SUBJECT: INSPECTION & MODIFICATION OF ELEVATOR

SERVICE BULLETIN

Service Bulletin M20-185

Figure I

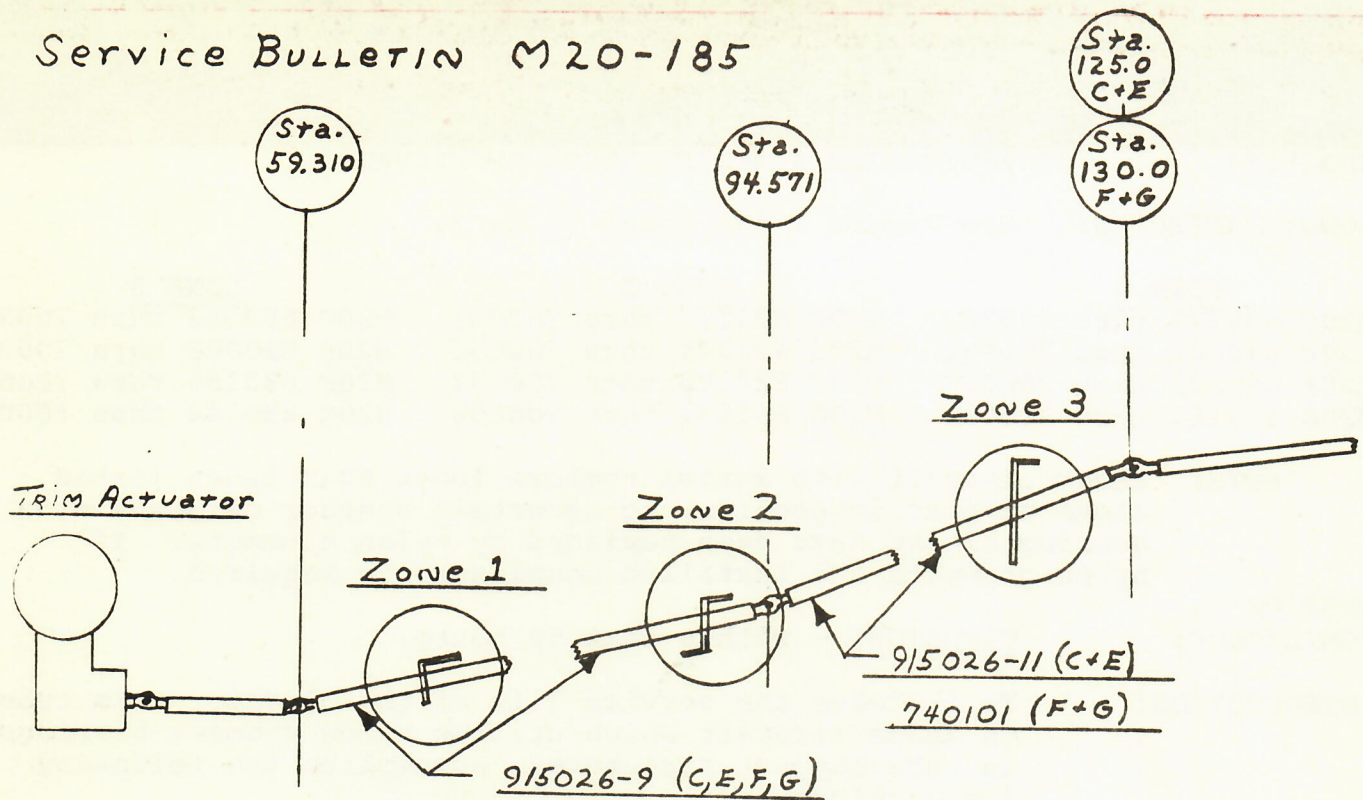
- (c) Left side fuselage panel
 2. Remove those trim tubes which pass through nylon grommet bearing supports (Figure I).
 3. Check wear of the two tubes in Zones 1, 2, 3 as indicated in Figure I.

4. If tube wear exceeds .007 per wall or .014 reduction in diameter, tube replacement is mandatory and replacement tubes must be modified as indicated in steps 6 & 7.

5. If tube does not exceed limits indicated in step 4 proceed with steps 6 thru 10.
 6. Clean tube thoroughly with Solox or equivalent, in areas where tape is to be applied (Figure II).

Figure II

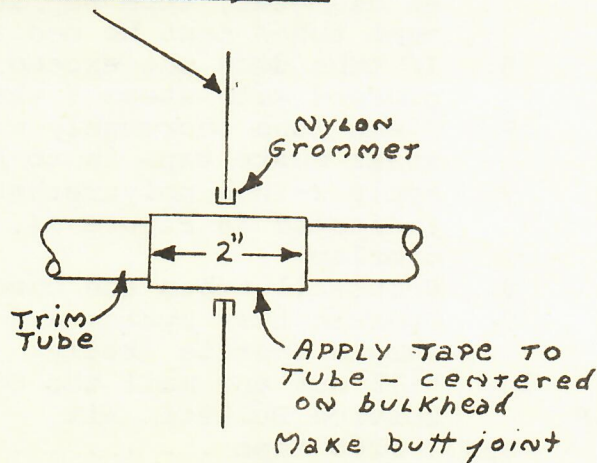
7. Apply 2-inch polyurethane tape #Y-9265 on tube as indicated in Figure II. Make butt joint, do not overlap.
 8. Reinstall tubes and check for proper placement of tape.
